SSD 7047

Response to Submissions and Amended Proposal

Interactive Display System - SICEEP

Sept 2016 ■ 15048

Figure 1 – Public Realm Signs included in the Project Deed of November 2013 and discussed at the August 2014 DRP

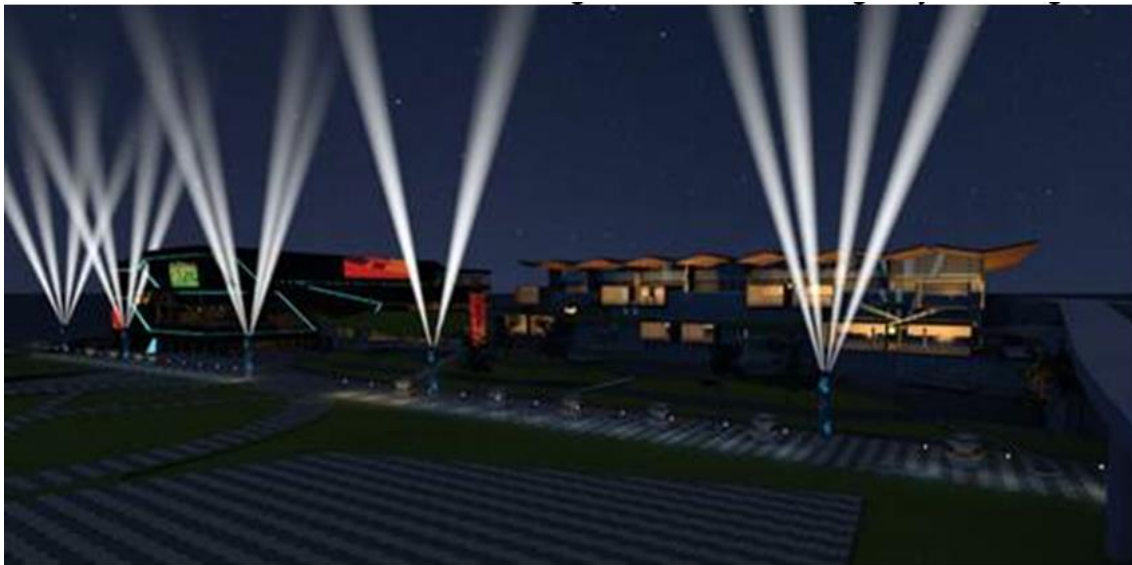
- removal of two LED signs from the ICC Convention Centre
- removal of one sign on the ICC Exhibition Centre;
- reduction in size by 50% of two other signs on the ICC Exhibition Centre;
- expansion of the LED installation at the entrance of the ICC Theatre (i.e. T-01);
- removal of three signs from the ICC Theatre;
- expansion of one sign on the ICC Theatre;
- one large sign on the ICC Theatre was split into three separate signs; and
- the proposed public domain signs were combined with precinct markers.

- *The DRP questioned the potential for conflict of signage within Tumbalong Place with artwork proposal. Further investigation required.*
- *DHL noted further work was being undertaken on wayfinding within the public realm and this will influence signage proposal within the public realm.*
